North Coast Regional Water Quality Control Board

INSPECTION MEMO

BoDean Co Inc. Santa Rosa Hot Plant, 1060 Maxwell Drive, Santa Rosa, Sonoma County

WDID #: 1 49I017446

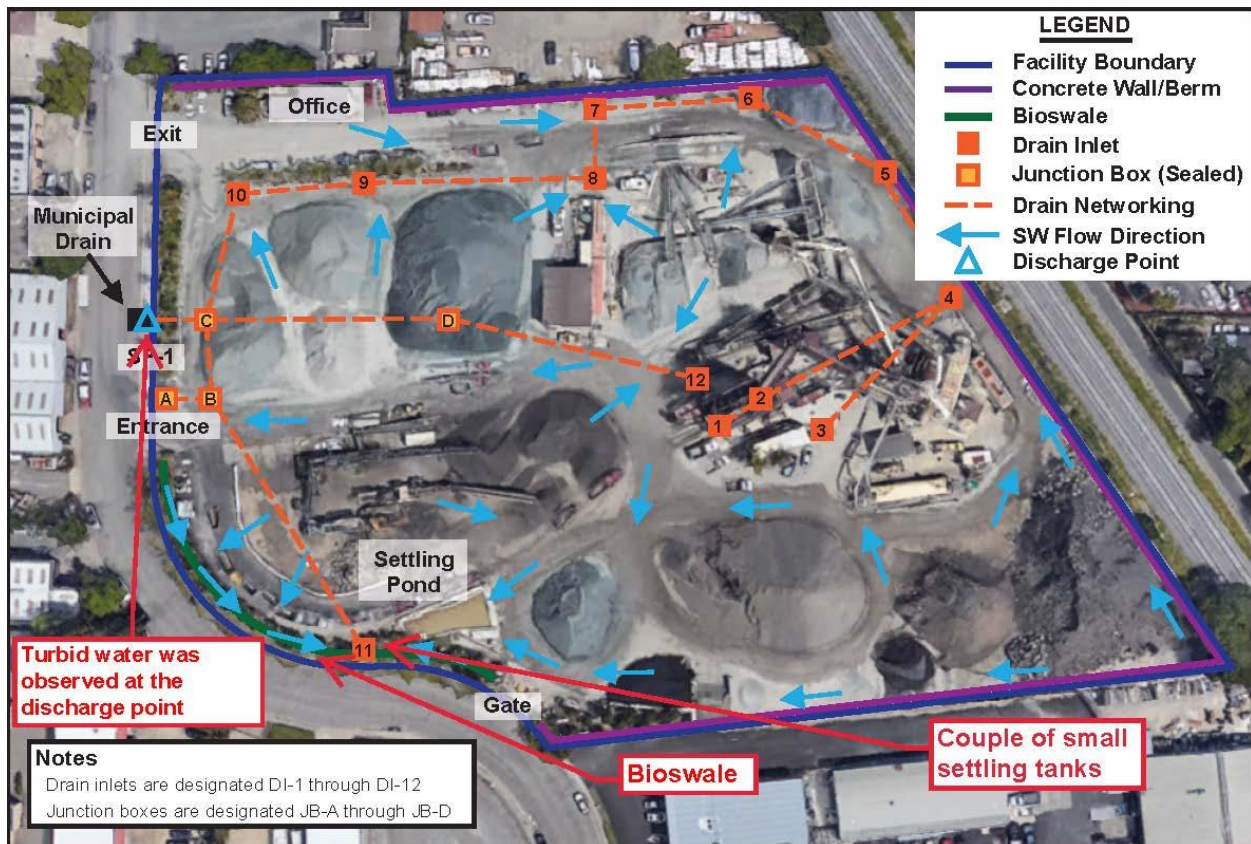
Picture 18 – Site Map showing the locations of the discharge sampling point as well as the existing bioswale and settling pond. Base site map dated November 8, 2017, as submitted by EPS on behalf of Dean Soiland, via SMARTS. Text boxes with arrows added for clarity by Regional Water Board staff Farzad Kasmaei.
